Report of the mechanical evaluation of LT428

Photo 1: Front panel

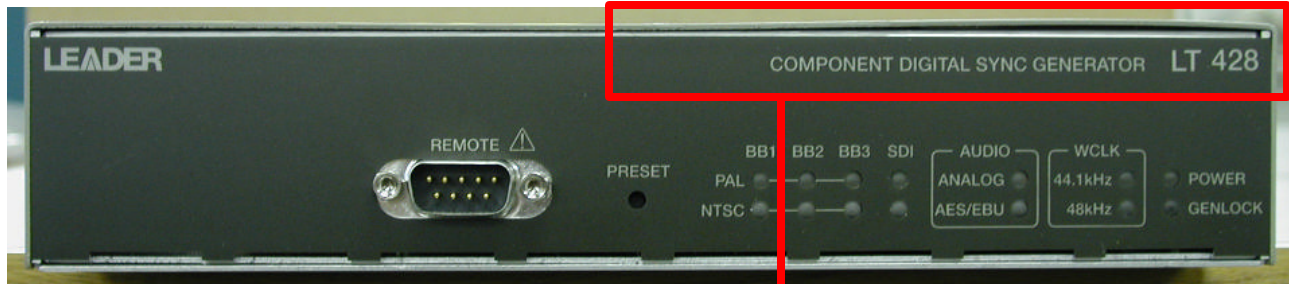
1. A gap between front panel and upper cover

As shown on the attached photos, there is a gap between upper portion of the front panel and Upper cover of the case.

As it is the face of the LT428, do not you think it looks cheaper?
